Subject: Response to Request for Additional Information Regarding License Amendment  
Application for Measurement Uncertainty Recapture Power Uprate  
(License Amendment Request No. 05-0007) (TAC No. MD5240)

## RESPONSE TO REQUEST FOR ADDITIONAL INFORMATION

### DAVIS-BESSE NUCLEAR POWER STATION, UNIT NO. 1

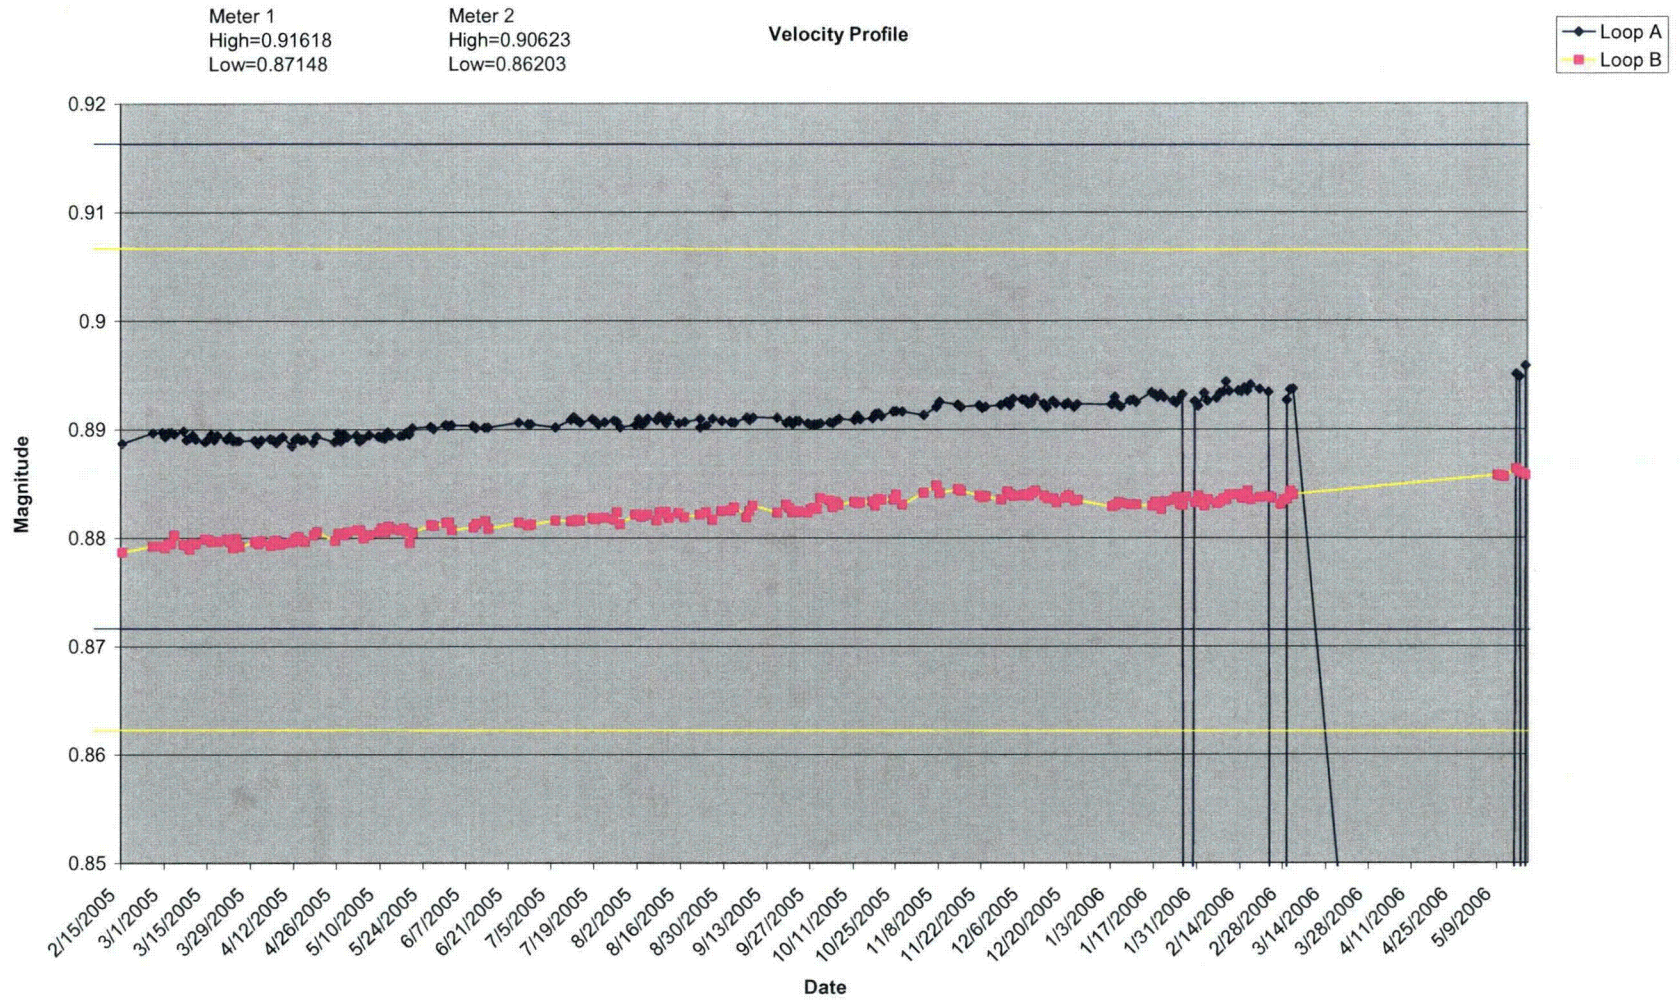
- 21. SRXB: Please provide a description and drawings of the Alden Laboratory test configuration used for the plant's current piping configuration and variations of the plant's configuration. Identify any differences between the test and plant configurations. Reference I-10 from your submittal of April 12, 2007, may be provided to address part of this request to alleviate preparation of additional documentation.**

The test configuration, as described in Section 2.3 of ER-227 (pages 5 and 6), can be compared to the as-built plant configuration using drawing M-206D (included as part of Enclosure 9).

For the plant configuration, main feedwater (MFW) train 1 has approximately 33 feet of 18 inch diameter schedule 80 straight pipe prior to the 90 degree elbow, and MFW train 2 has approximately 31 feet of 18 inch diameter schedule 80 straight pipe prior to the 90 degree elbow. On both MFW lines there is 10 feet of 18 inch diameter schedule 90 pipe between the centerline of the elbow's inlet and the LEFM. FENOC is unable to confirm from plant drawings whether the 90 degree elbow is a long radius elbow, as was used in the test configuration. However, this potential difference between test configuration and plant configuration would not be significant, based on the long length of straight pipe between the outlet of the elbow and the inlet of the LEFM.

One notable difference in piping configuration between the test set up and plant installation is the length of piping on the inlet to the elbow that is prior to the LEFM. Whereas the tested configuration included flow straighteners as part of the standard test equipment used by Alden Research Laboratory, the plant has a longer length of 18 inch diameter straight pipe prior to the

LEFM, which allows for more natural straightening of the flow prior to entering the elbow. This difference is judged to be insignificant.

The other notable difference between the test set up and the plant installation is that the test piping was laid out horizontally while the plant piping is a vertical run of piping up to the elbow, with the flow direction from bottom to top. This difference is judged to be insignificant.

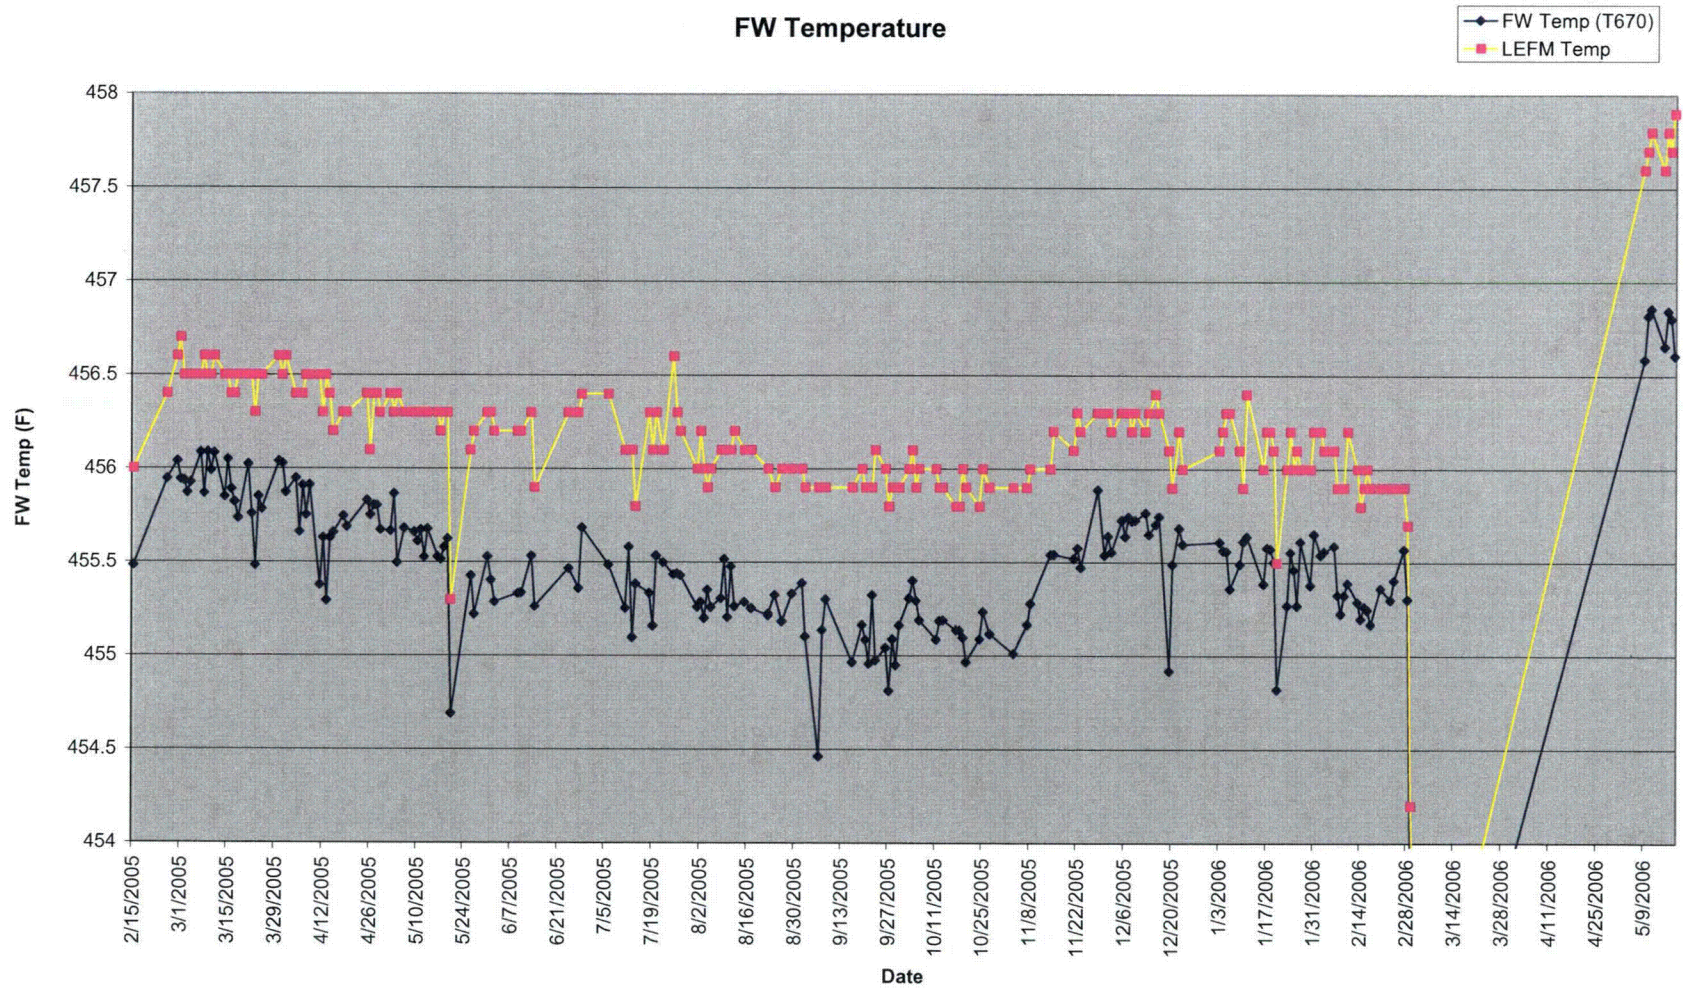
**22. SRXB: Please provide a summary of the Alden Laboratory test results and application/comparison of those test results to plant operation. Include a representative set of test data if not provided in Request 21, above.**

The following graph shows a trend of the velocity profiles from February of 2005 until May 2006. This plant data is consistent with velocity profile data shown in Table 3 (page 9) of ER-227 (Enclosure 10). The rise in the velocity profile of the plant data is believed to be due to the decreasing signal to noise ratio as the transducers aged over time.

**FW Temperature**

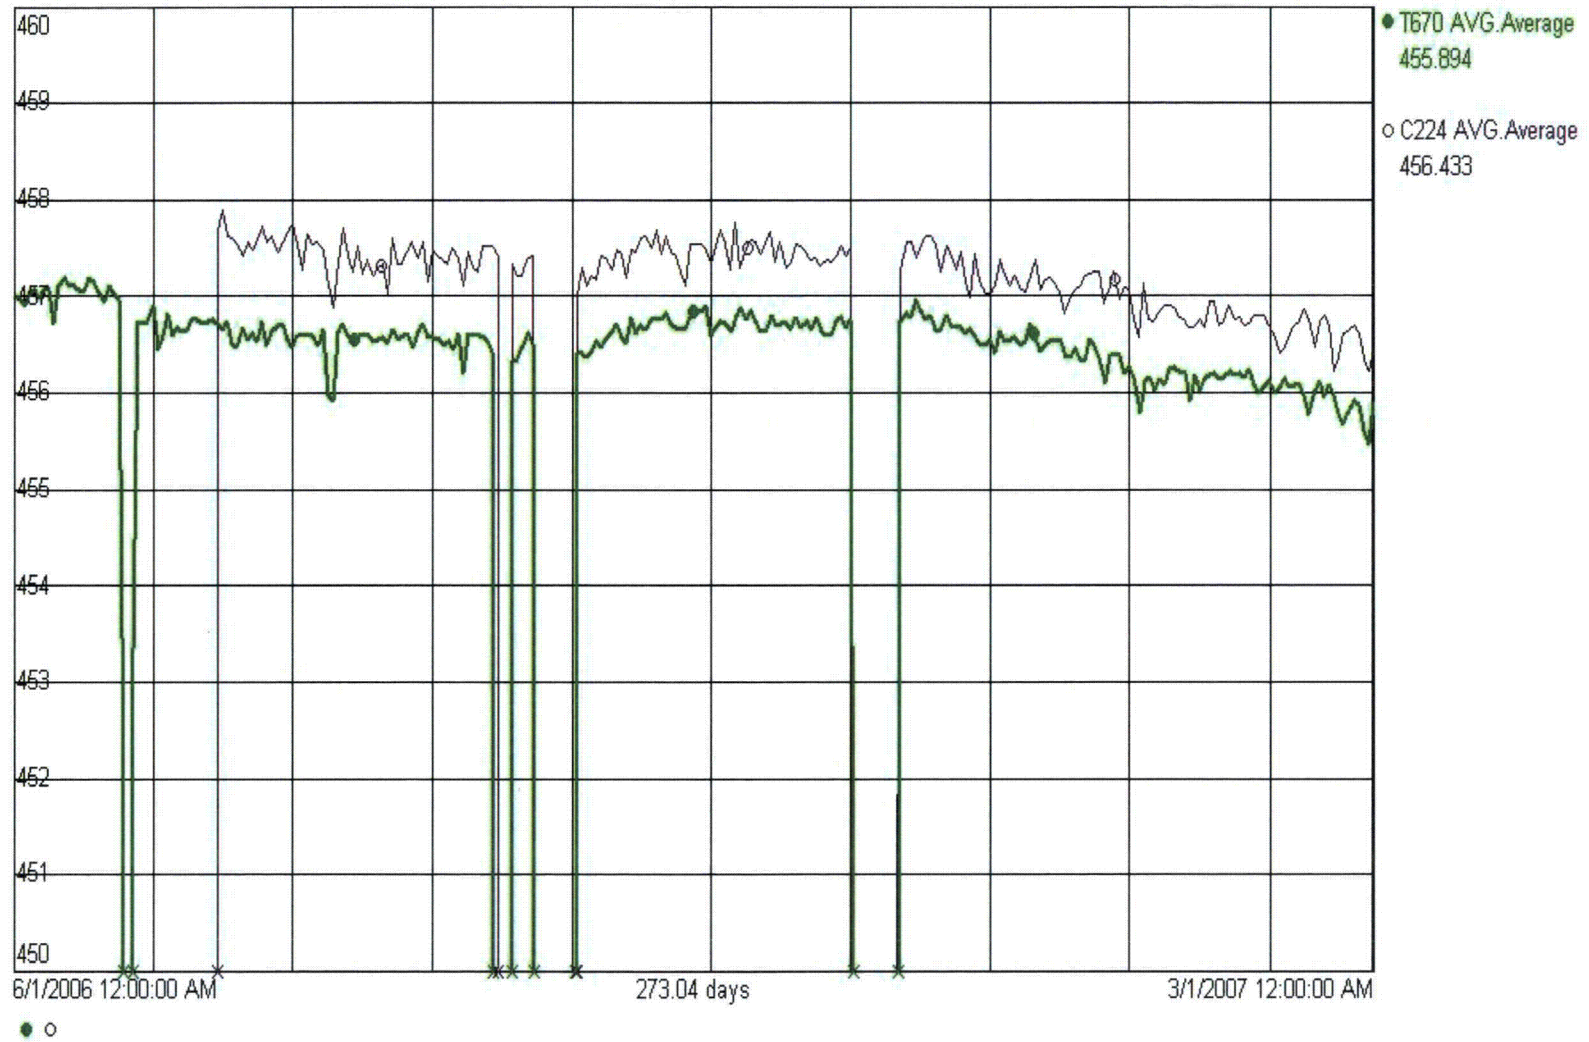
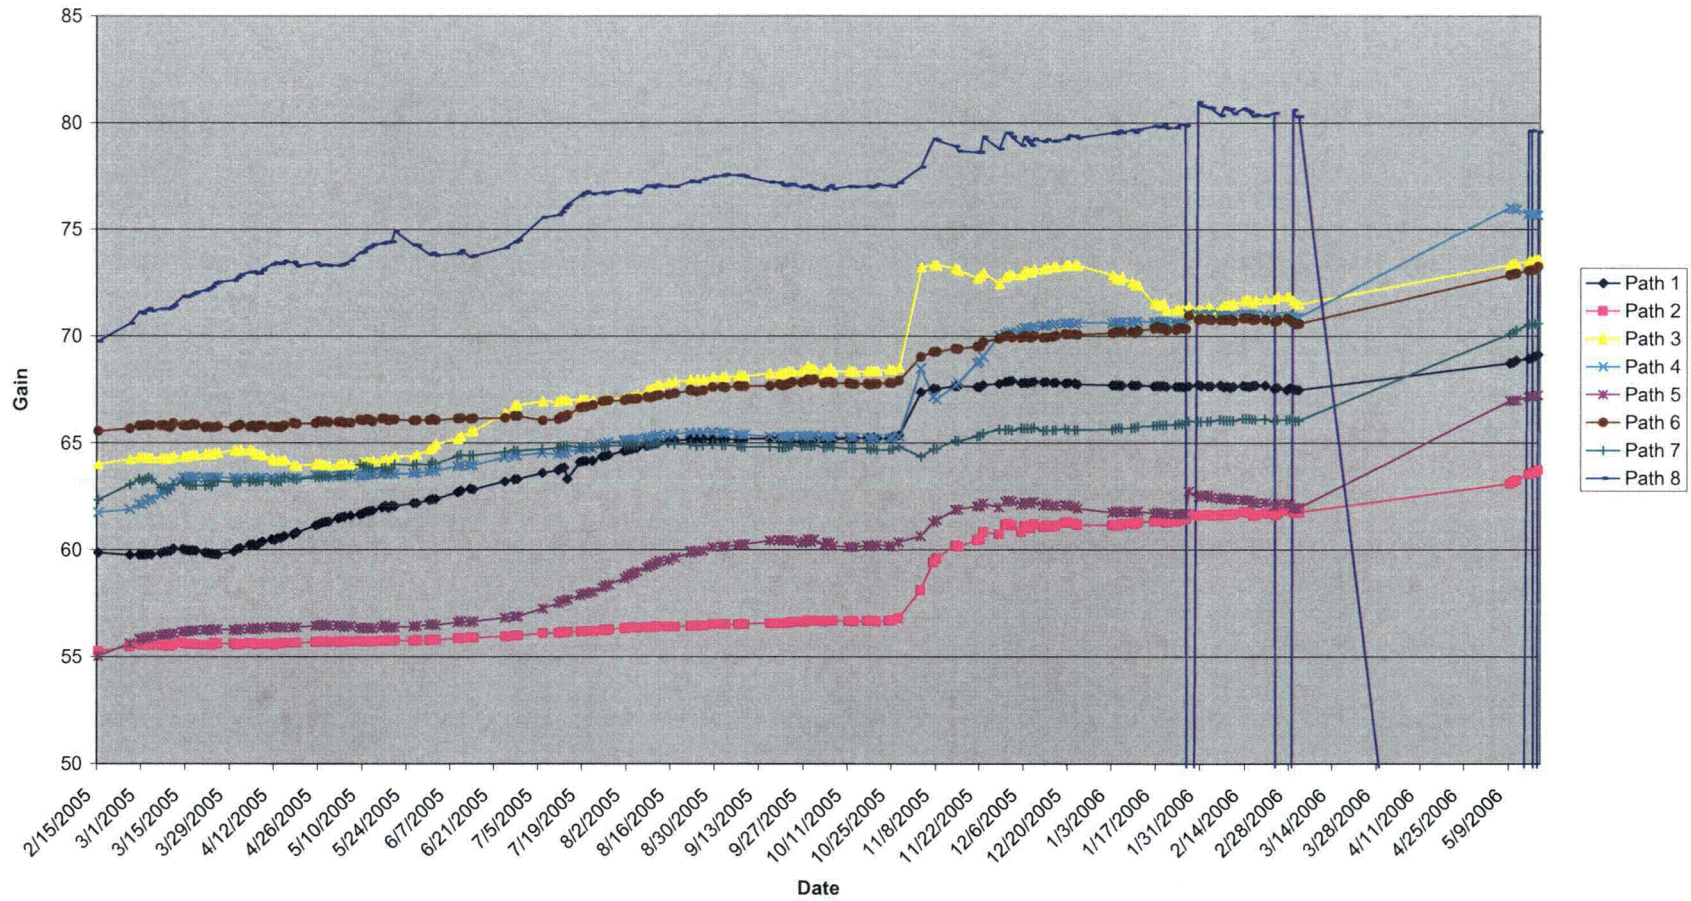
**23. SRXB: Please provide a summary of LEFM characteristics before and after replacement of the 32 transducers in June 2006. This summary should contain a comparison to other feedwater measurement instruments over a sufficient time span to enable a valid comparison of before and after characteristics.**

A review of the data for Feedwater (FW) temperature, which is one of the inputs to the heat balance calculation, shows consistency in trending between computer point C224 (LEFM FW temperature) and computer point T670 (RTD FW temperature) before and after June of 2006. The trends in LEFM FW temperature show no changes in the performance before or after the change out of the transducers in June of 2006. The downward spike in data for the graph of FW temperature prior to June of 2006 was due to the 14<sup>th</sup> Refueling Outage (14RFO). The downward spikes in the data for the graph of FW temperature after June of 2006 were due to plant maintenance outages or maintenance on the LEFM.
